**MONTEREY PENINSULA WATER
SUPPLY PROJECT**

SLANT WELL INTAKE SYSTEM – CIVIL WORK

ADDENDUM NO. 2

July 10, 2019

Revised Drawings

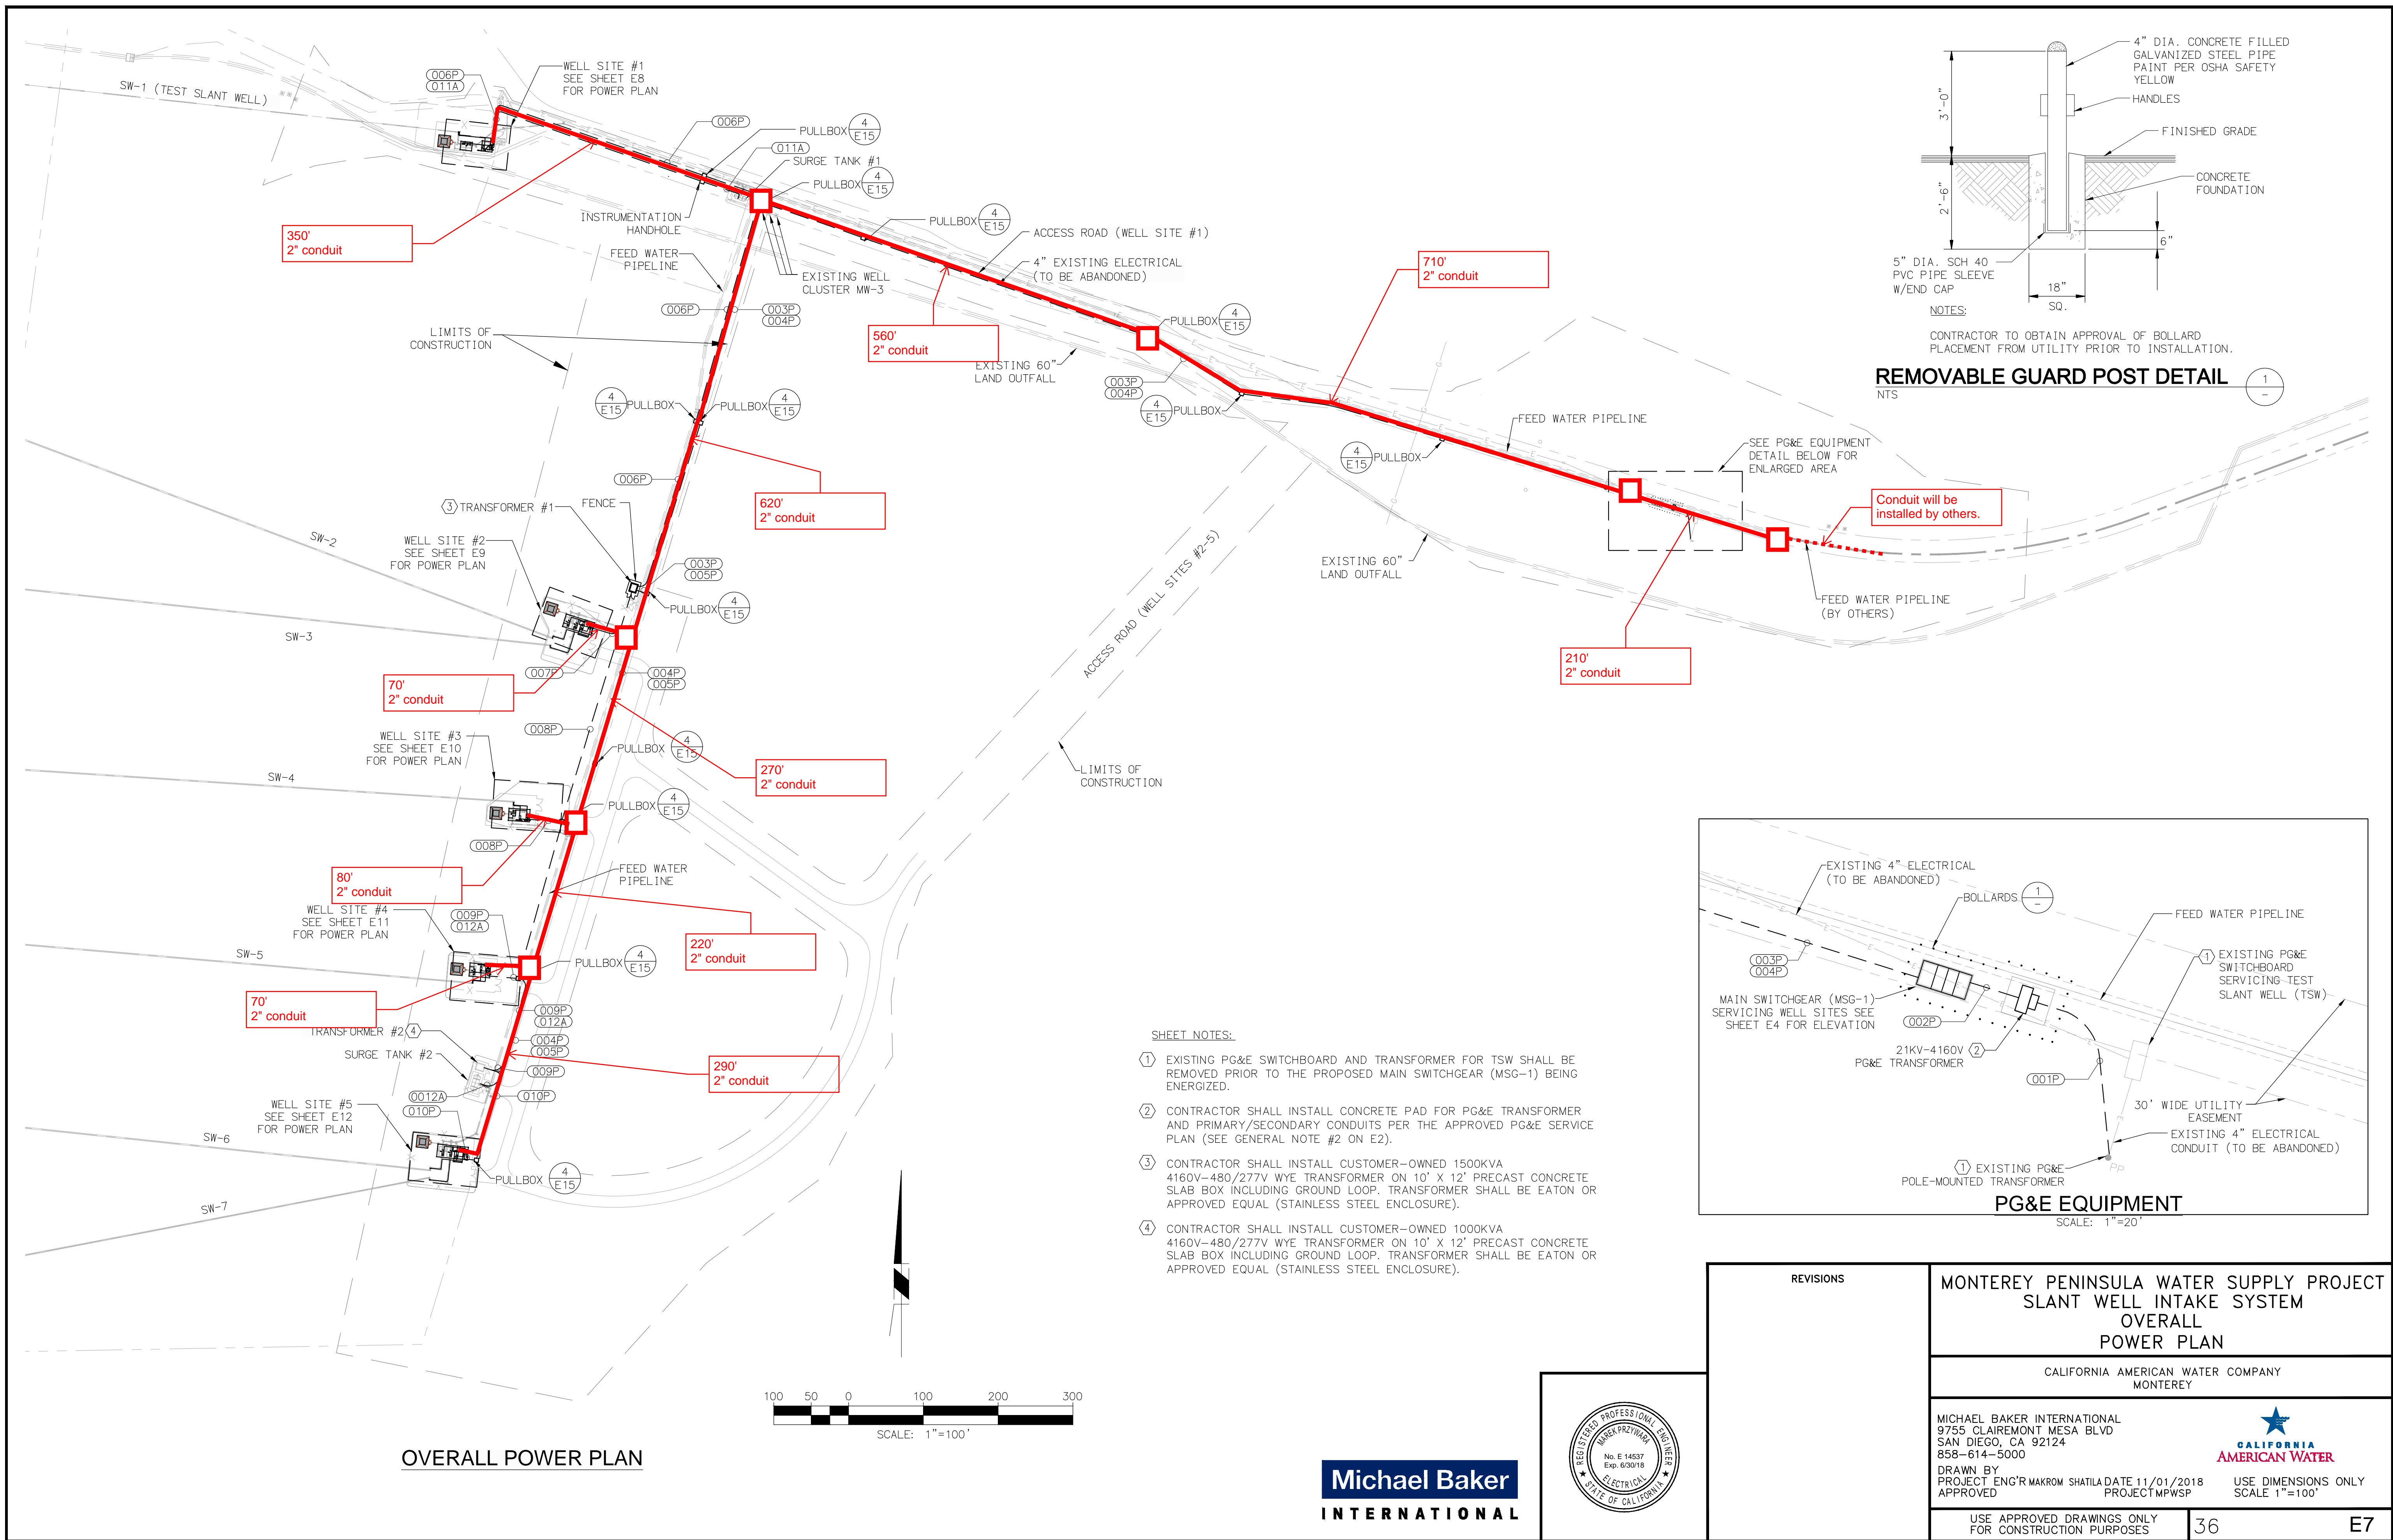
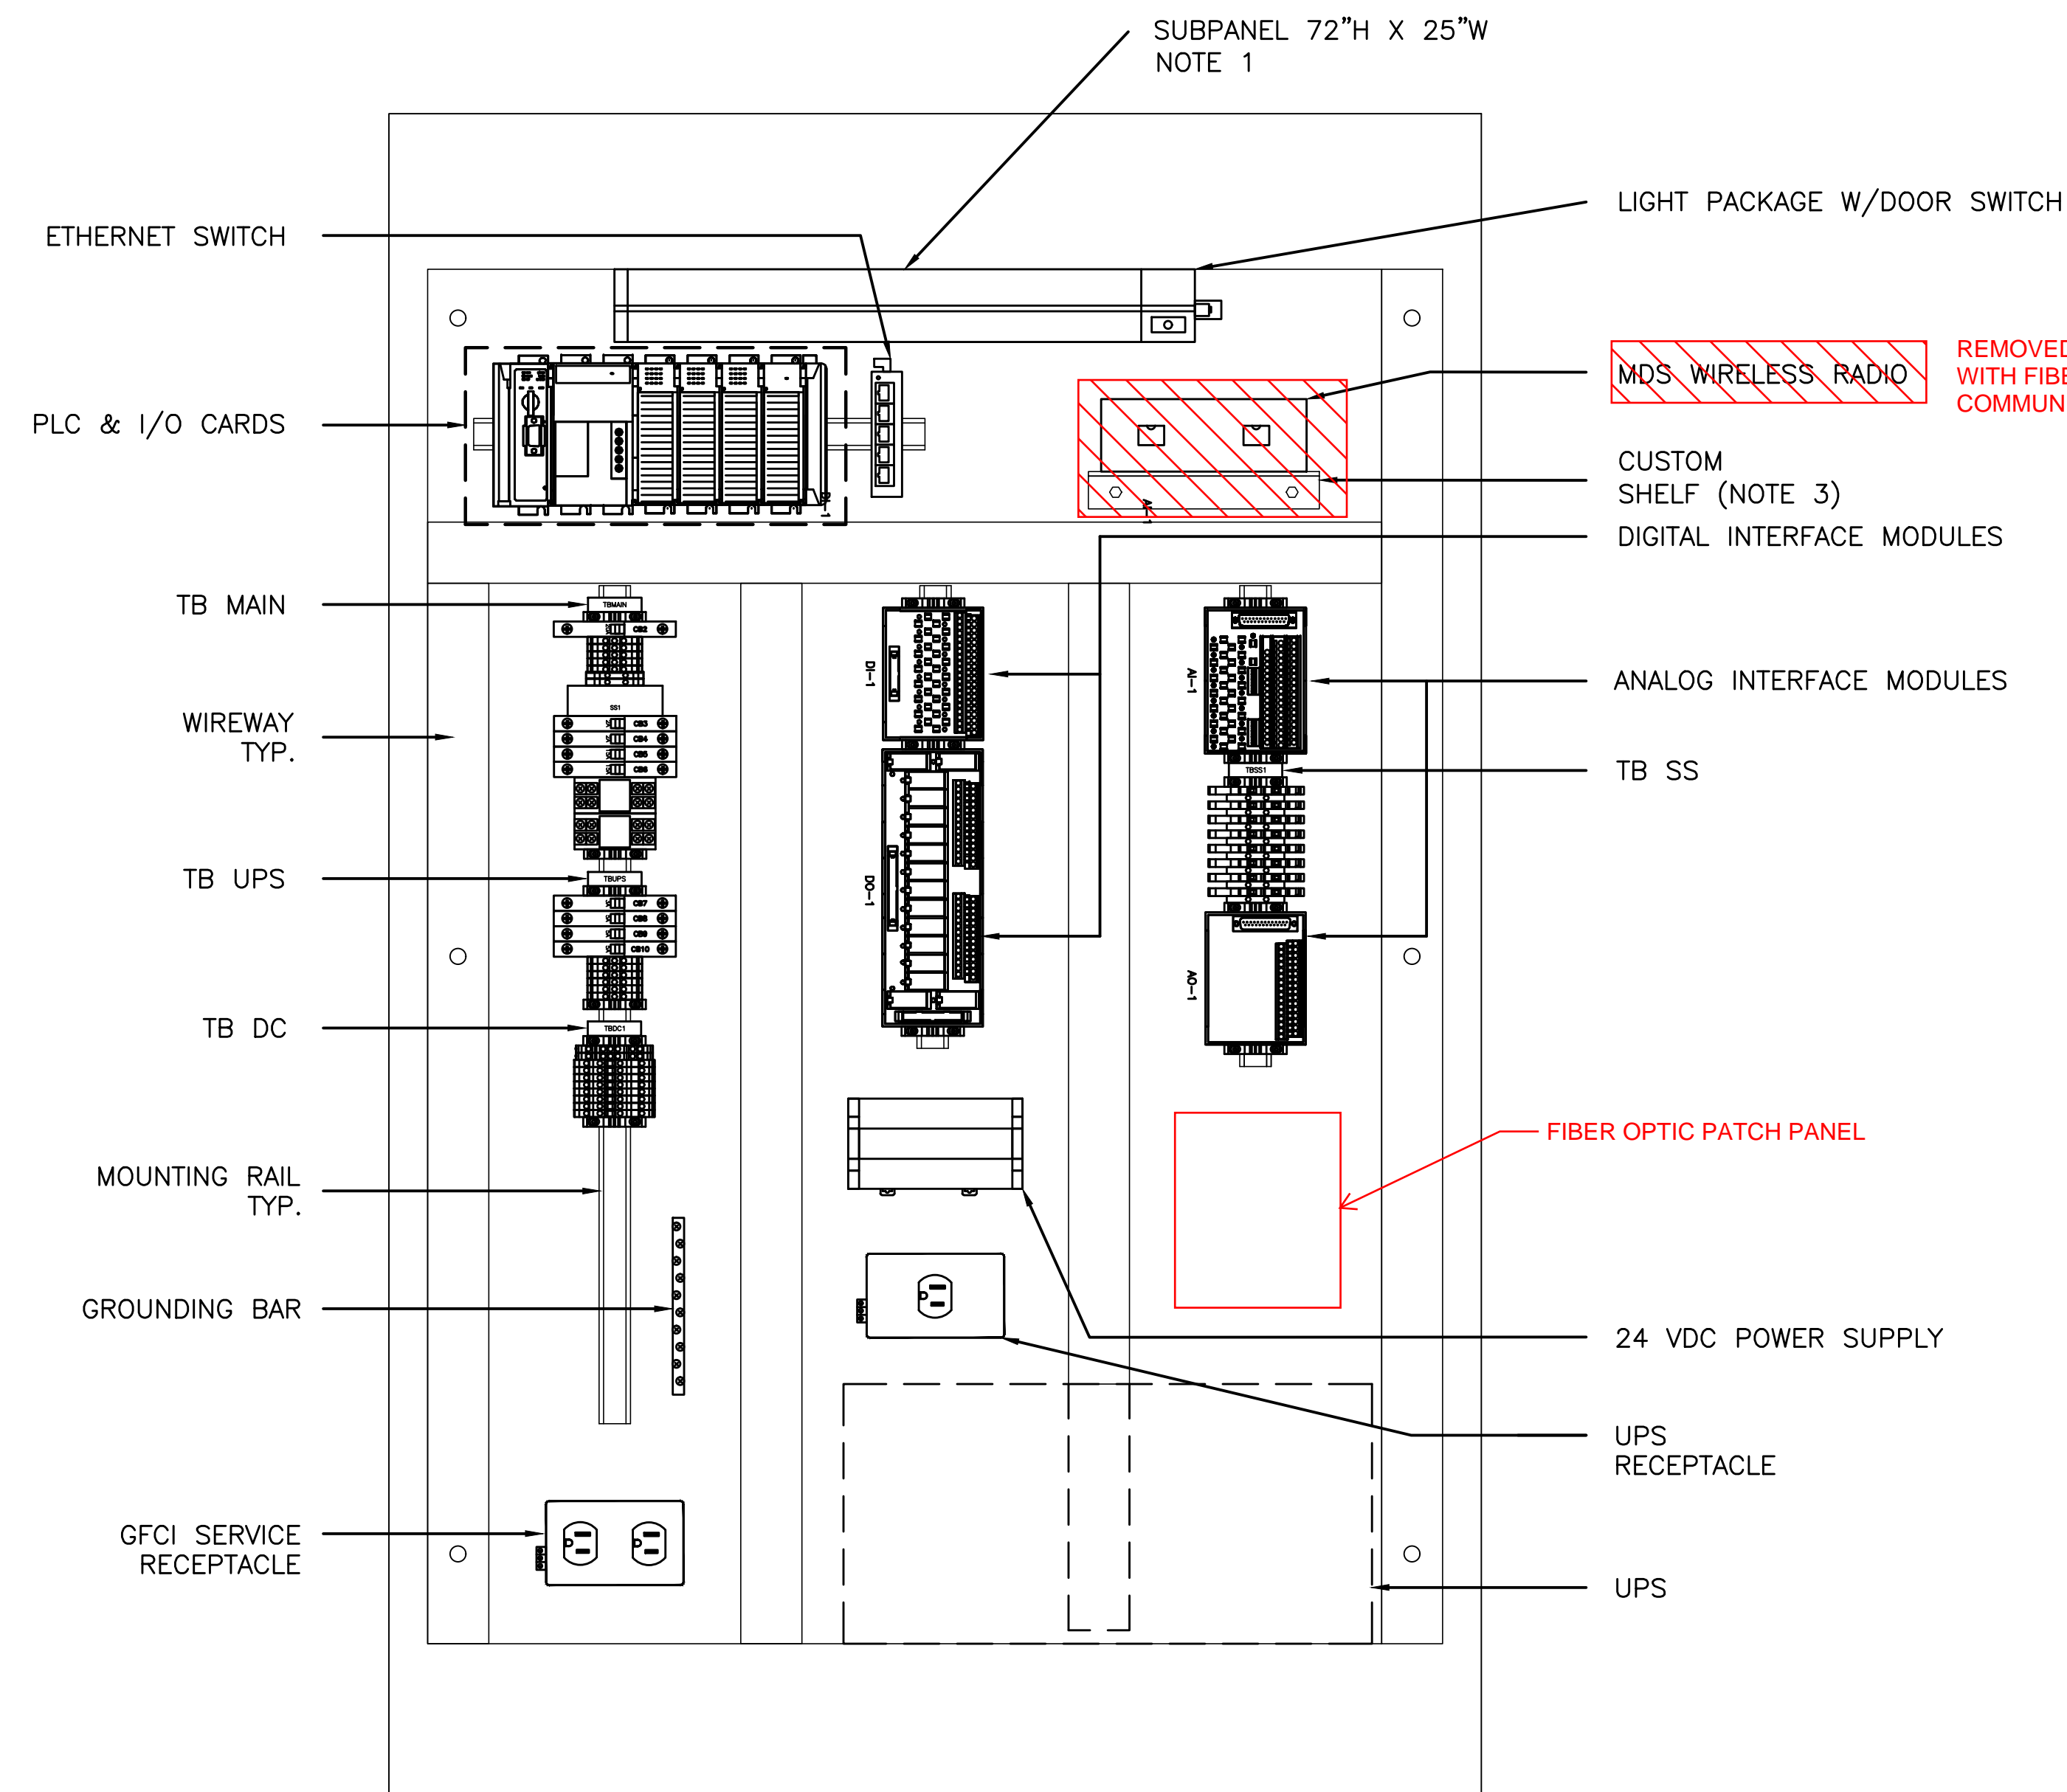
2.	<p>Question: Will fiber optic (FO) conduit and pull boxes be required?</p> <p>Answer: Yes. Fiber optic conduit, pull boxes, and FO patch panels for each well will be required. Please see the attached (Attach 3 - Sheet E7) with red lines illustrating PVC conduit lengths and approximate pull box locations required for fiber optic wire installation. In addition, wireless radio is no longer being implemented for SCADA communication. Therefore, see revised Control Panel in Attachment 1 - Sheet E19, where MDS Wireless Radio equipment has been removed and a Fiber Optic Patch Panel has been added. In addition, please see Technical Specification, Attachment 4 – <i>Section 13321 Fiber Optic Cable and Equipment</i>. This tech spec is from CDM Smith who is the design-build lead for the seawater desal plant. The FO patch panel and terminations need to be consistent with the desalination plant equipment.</p> <p>NOTE: Conduit, pull boxes, and FO patch panels in each pump control panel are the only components of the FO system that are part of this bid item. The installation and connection of fiber optic cable (12-strand multi-mode) will be performed by others, from the desalination plant to the well sites.</p>
